Document: "Response to NJDEP Comments on Parcel 34- Revised LWPA"

OFFICE OF ASSISTANT CHIEF OF STAFF FOR INSTALLATION MANAGEMENT  
U.S. ARMY FORT MONMOUTH  
P.O. 148  
OCEANPORT, NEW JERSEY 07757

**SUBJECT: Revised Letter Work Plan Addendum for Parcel 34, Building 2567  
Fort Monmouth, New Jersey**

**FIGURE 1**  
**Layout of Parcel 34 (Building 2567) and Sampling Locations**

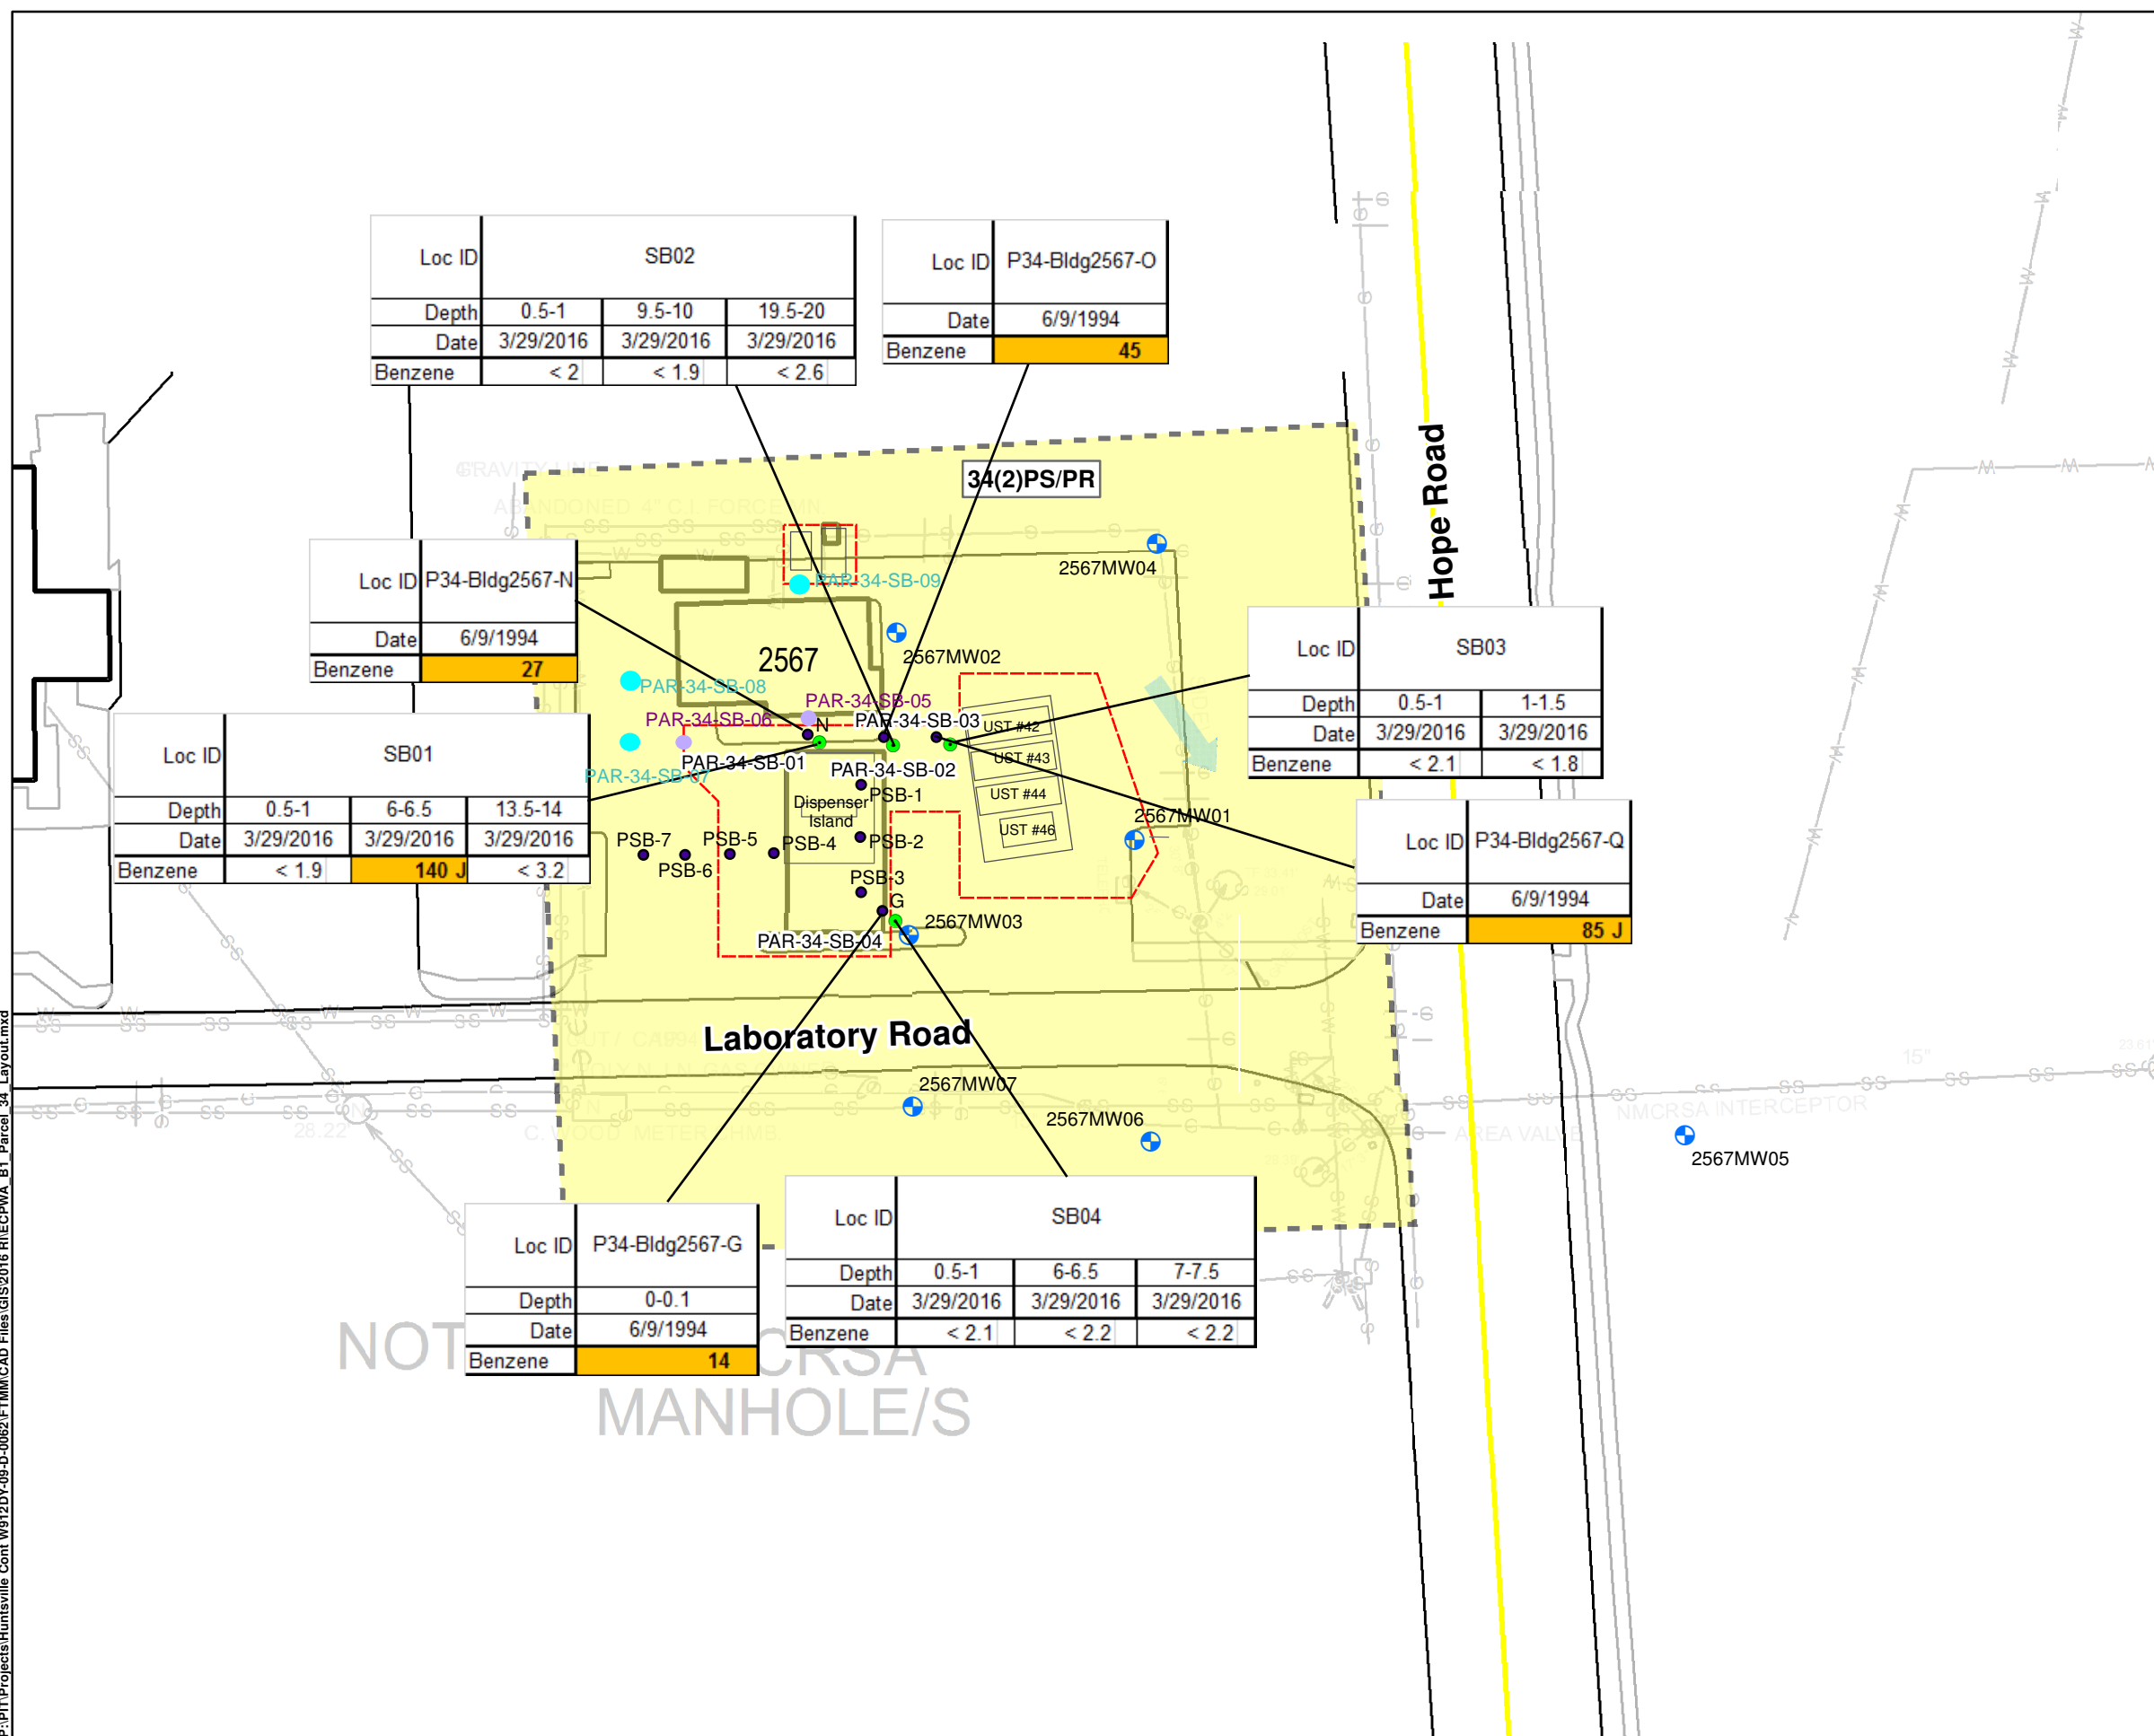
The purpose of this Revised Letter Work Plan Addendum (RLWPA) is to address the NJDEP comments provided in your letter dated July 28, 2016 and to provide an overview of the revised LWPA for Parcel 34, Building 2567. As proposed in our July 7, 2016 LWPA, 4 additional borings (2 primary and 2 contingent) will be installed to support the supplemental environmental investigation of Parcel 34, Building 2567, located within Charles Wood Area (CWA) of Fort Monmouth (FTMM). Additional soil sampling as described in this LWPA will be performed to augment previous samples collected under the November 2015 Rev.1 Environmental Condition of Property (ECP) Work Plan Addendum (approved by NJDEP in Dec. 2015 letter). Additionally, grab groundwater samples will be collected to assess the groundwater condition in the western portion of the site if vadose zone soil samples indicate the need for groundwater sampling, as requested in your July 28, 2016 comment letter.

The ECP Work Plan Addendum (WPA) included four soil borings, PAR-34-SB-01, -SB-02, -SB-03, and -SB-04 collected at four of the highest soil benzene concentrations detected by Weston for a 1994 UST excavation as shown on **Figure B1**. Soil borings were advanced as described in the ECP-WPA. Based on the results, contaminants around the excavation area have been delineated both horizontally and vertically to the residential direct contact soil remediation standard (RDCSRS) with the exception of the northwestern corner near PAR-34-SB-01. PAR-34-SB-01 had a detection of benzene exceeding the RDCSRS at 6-6.5 feet below ground surface (bgs) (which is below the water table at this boring, as shown on the boring log provided in **Attachment 1**). In response to the NJDEP July 28, 2016 comments and to provide delineation of benzene, two primary soil borings (PAR-34-SB-05 and PAR-34-SB06) and three contingency borings (PAR-34-SB-07, PAR-34-SB08, and PAR-34-SB-09) are proposed and are shown on **Figure B1**. Up to 2 to 4 samples will be collected within each boring as described in **Table 1**. Primary samples will be run for VOC+TICs, and contingency samples will be extracted, held, and run for VOC+TICs pending results of the primary samples. Additionally, at borings PAR-34-SB-05 and PAR-34-SB06, grab groundwater samples will be collected using temporary wells.

Groundwater samples will be extracted, held, and run for VOCs+TICs pending results of the vadose zone soil samples.
